ADDENDUM NUMBER 2
ITB 16-ES-002 - US HWY #1 AND SR #442 FDOT LANDSCAPE BEAUTIFICATION PROJECT
CITY OF EDGEWATER

US 1 AND SR442 FDOT LANDSCAPE BEAUTIFICATION

US 1 AND SR442 BEAUTIFICATION
IRRIGATION PLANS
LAYOUT SHEET
VOLUSIA COUNTY, FLORIDA
CITY OF EDGEWATER

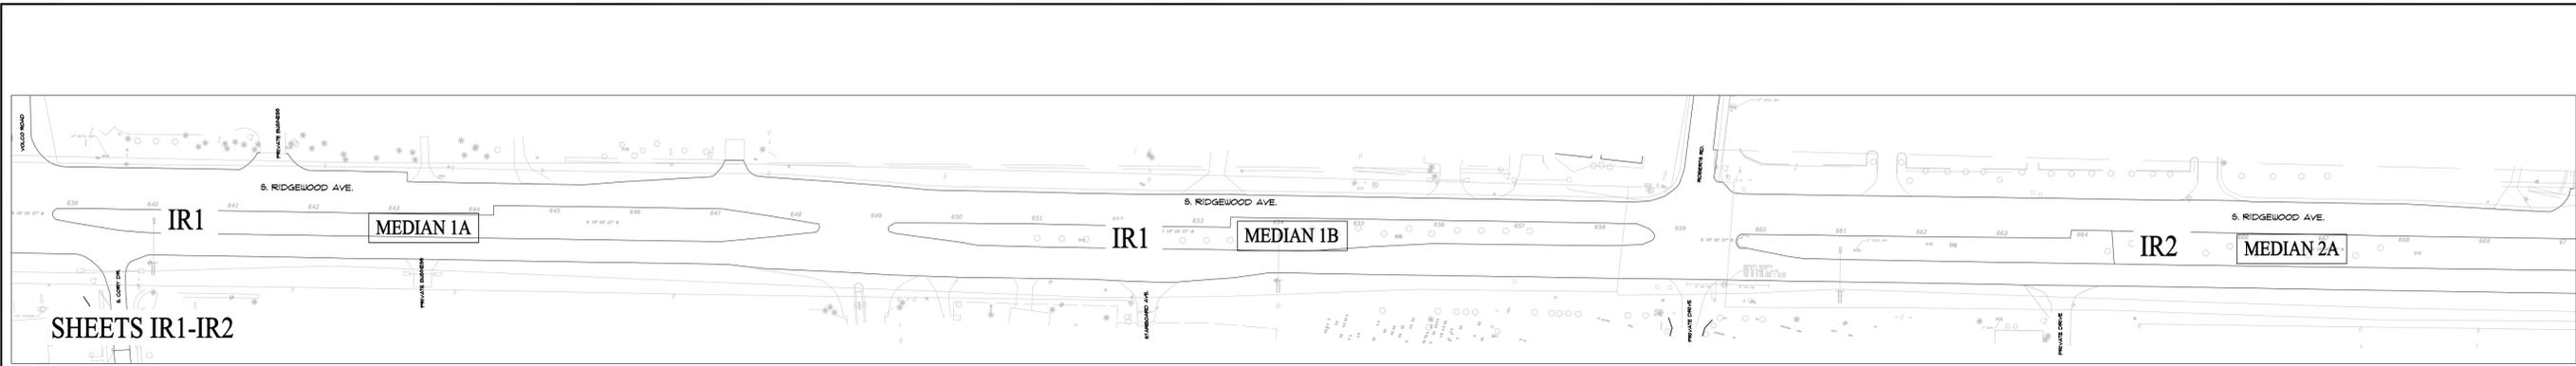
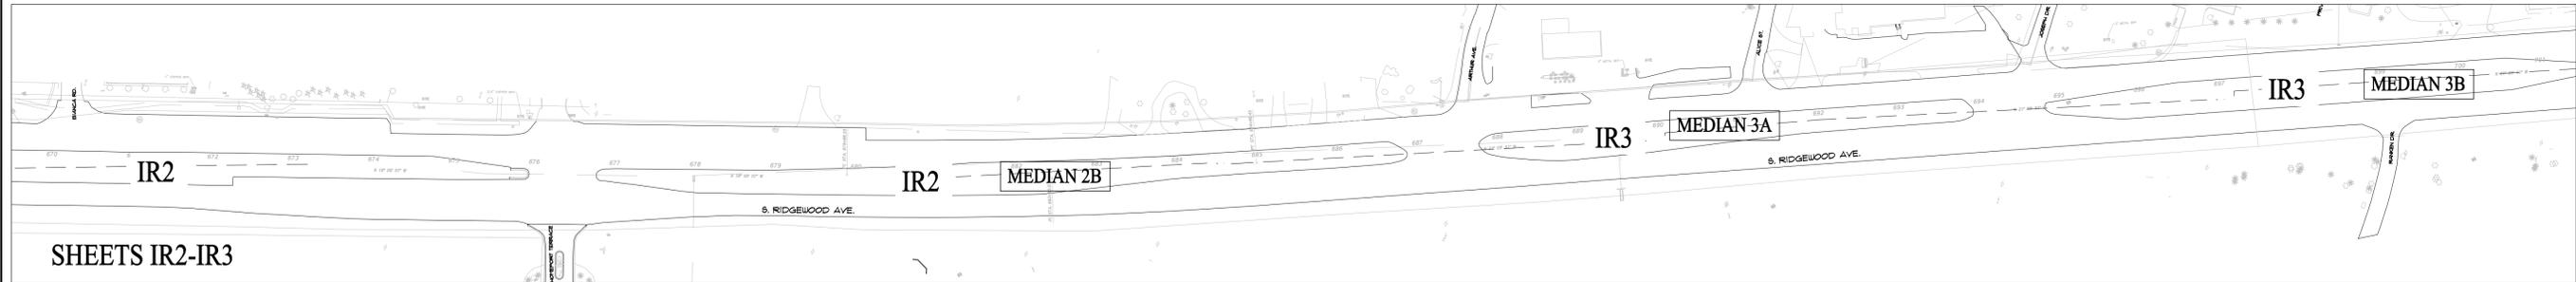
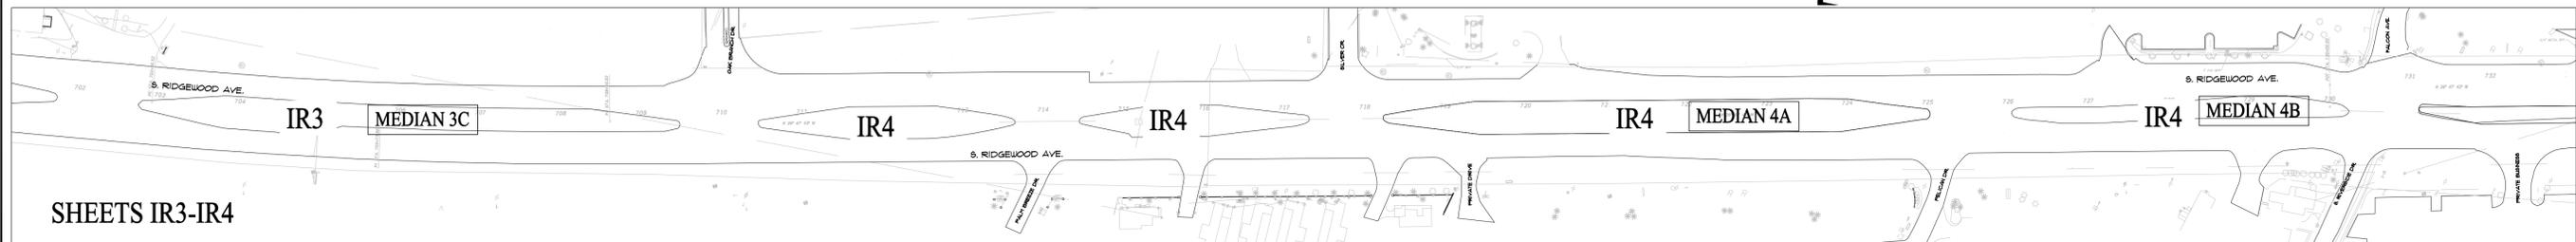
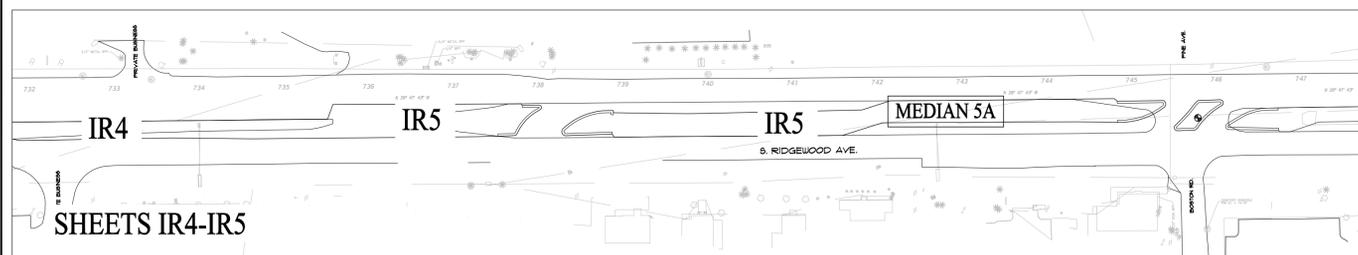
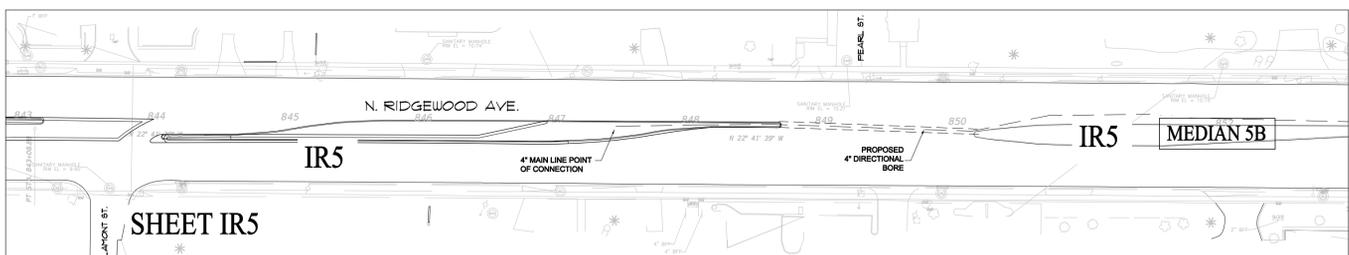
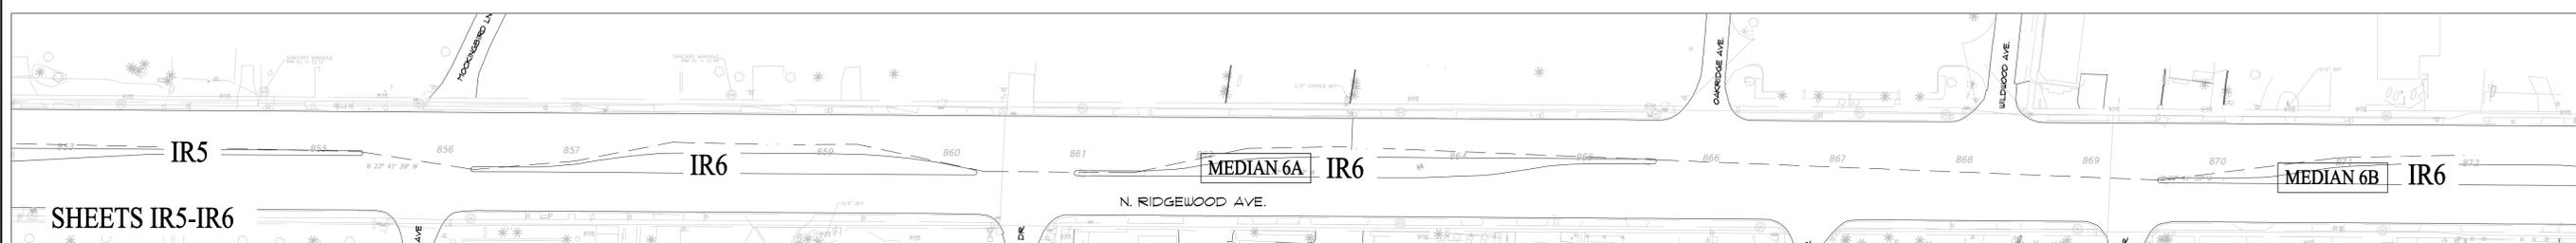
Q5. There are at least (15) 4" directional bores shown to be installed on this plan, however, there are (2) 3" and (2) 1 ½ directional bores listed on the bid tab?

Q6. The plans clearly do not identify the scope of the irrigation work to be completed fairly to all of the prospective bidders, there are many items unclear. I would suggest that a pre-bid meeting with the designer be held so that we can all understand what we are to irrigate, where our water source is and where the mainline and directionals are to be installed and what the correct sizing should be.

A6. Pre-Bid meeting was held on August 17, 2016. Please see attached revised plans and bid sheet.
